CITY OF ALBUQUERQUE

RE: 13909 Lomas Blvd. NE
Grading and Drainage Plan
Engineer's Stamp Date: 06/14/21
Hydrology File: J23D003A1

Based upon the information provided in your submittal received 06/14/2021, the Grading and Drainage Plan is approved for Grading Permit (earthwork can get started for the earth pad on the house).

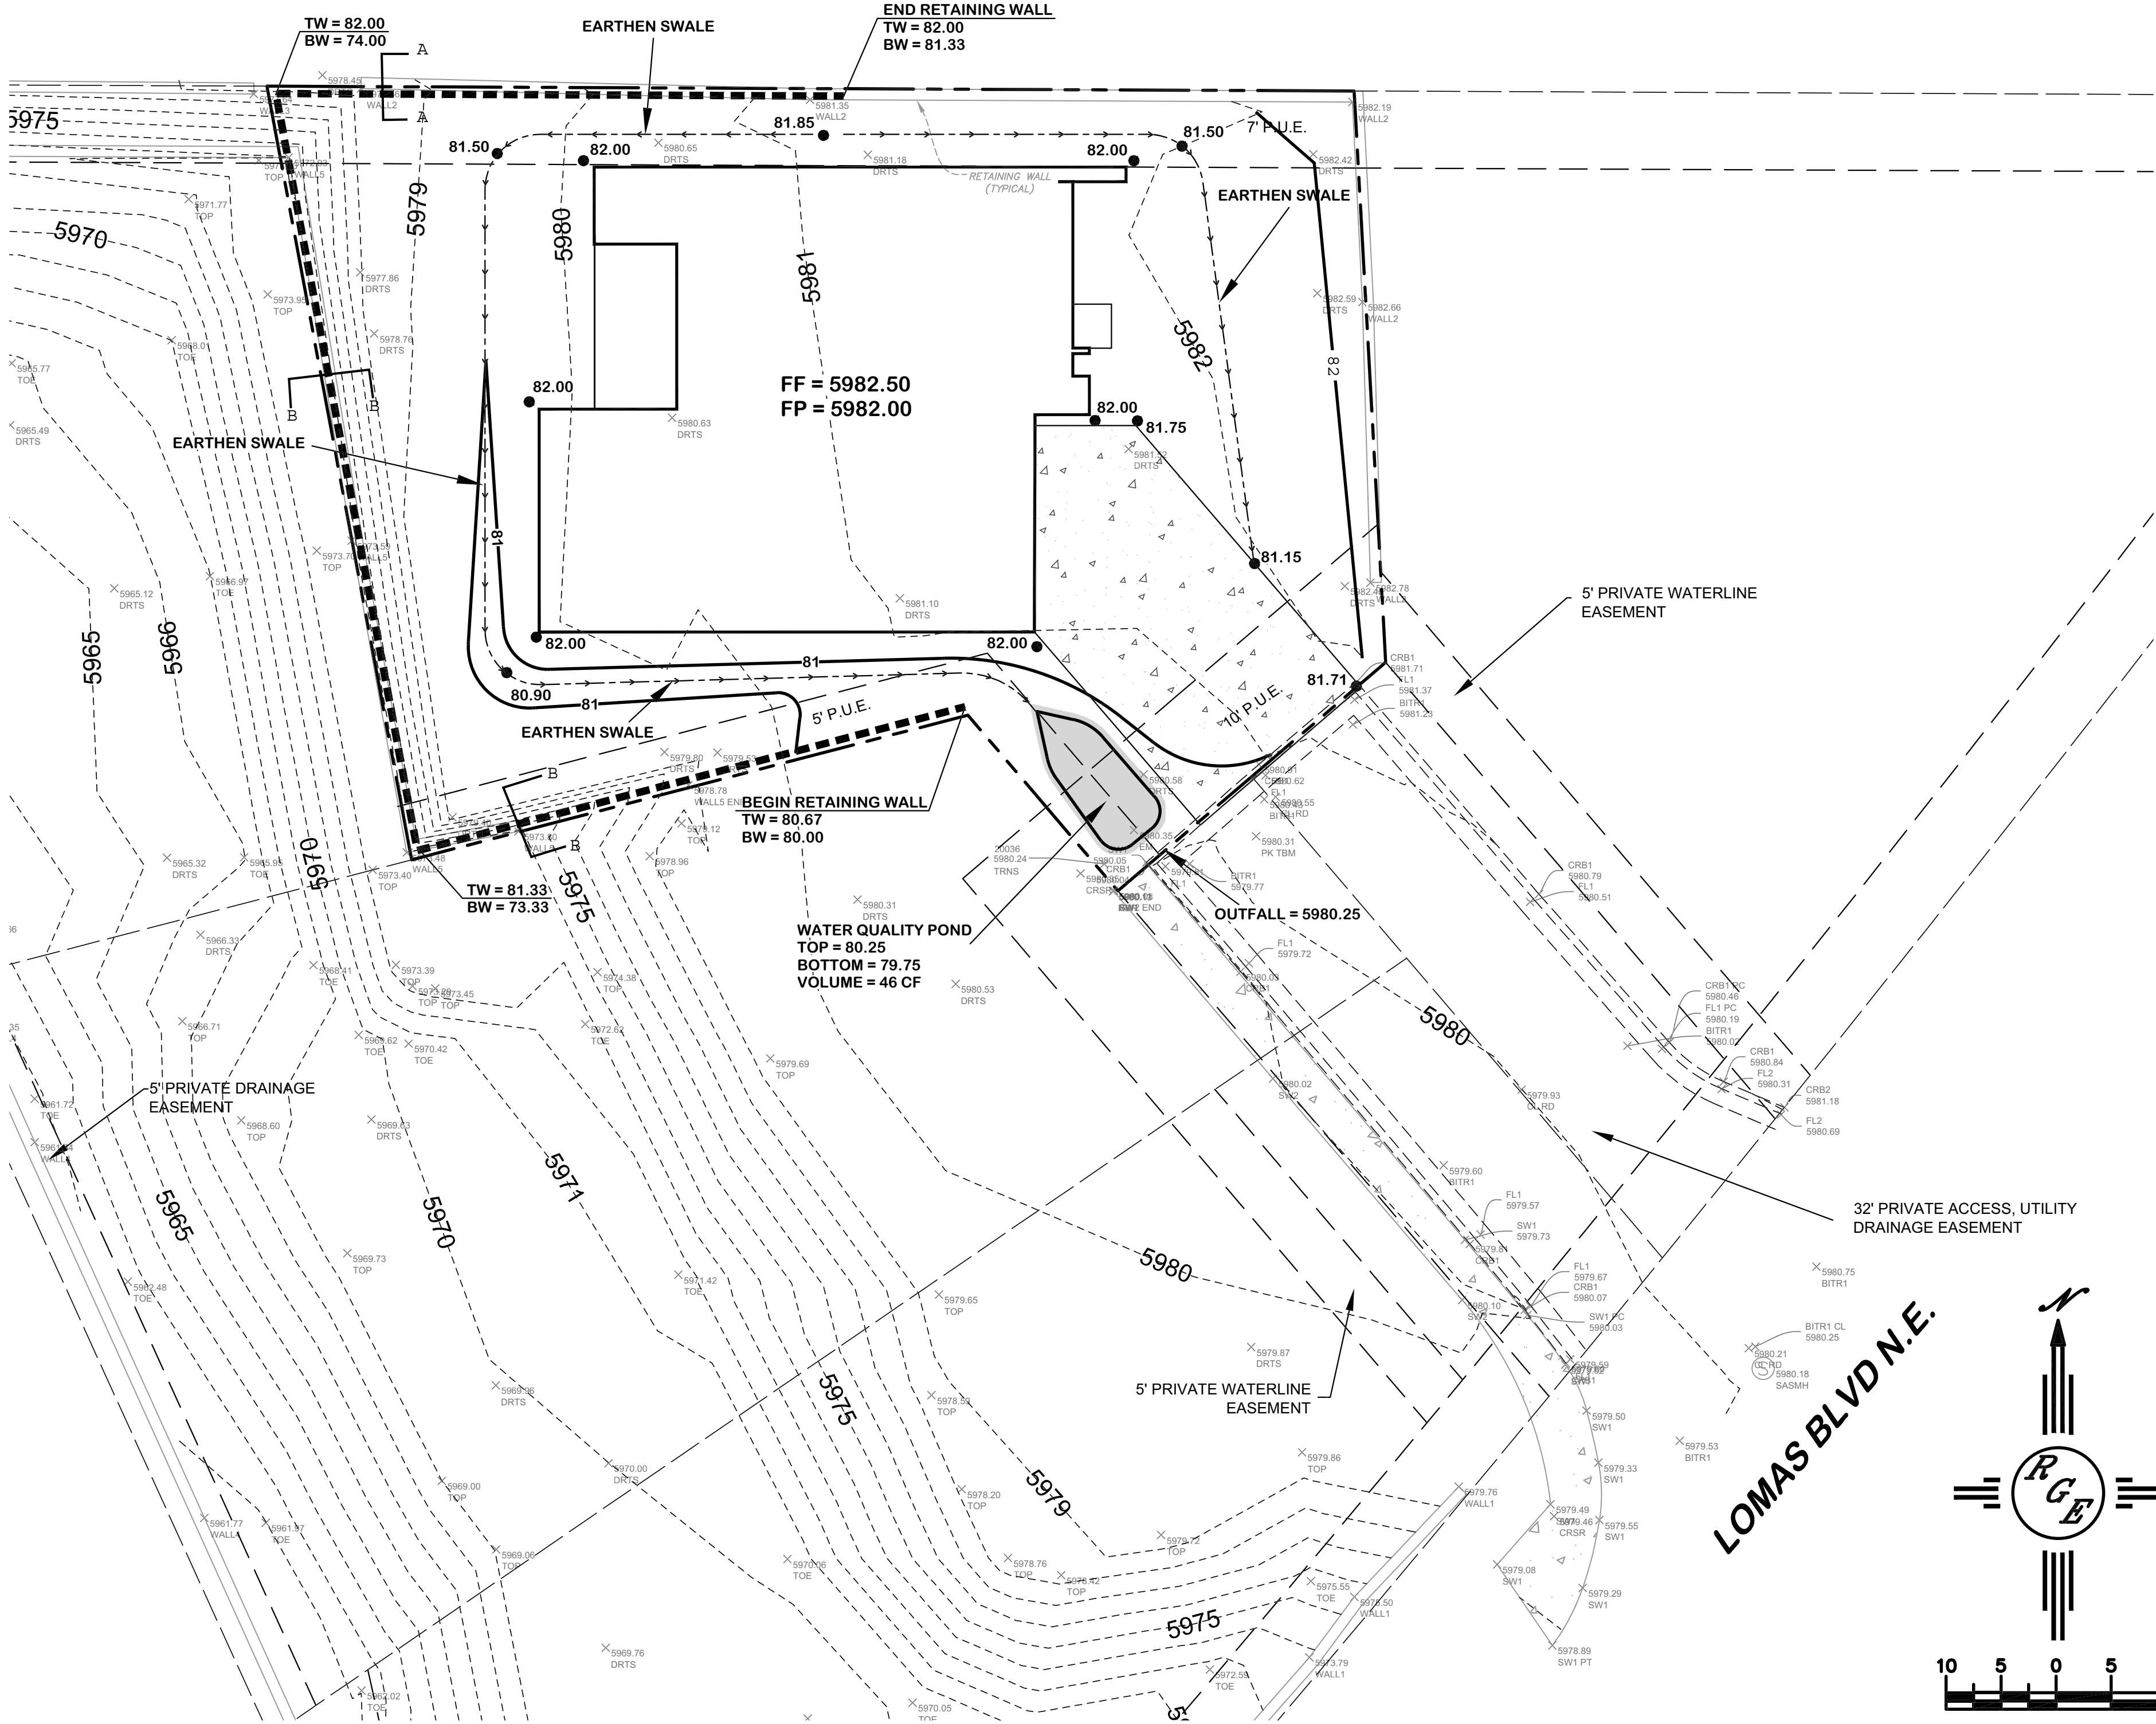
Once the grading is complete, a pad certification (meaning that the earthwork is complete) will be required prior to release from Hydrology during the Building Permit process. Also, at the time of pad certification approval, Hydrology will concurrently approve the Grading & Drainage Plan for Building Permit.

Prior to approval in support of Permanent Release of Occupancy by Hydrology, Engineer Certification per the DPM checklist will be required.
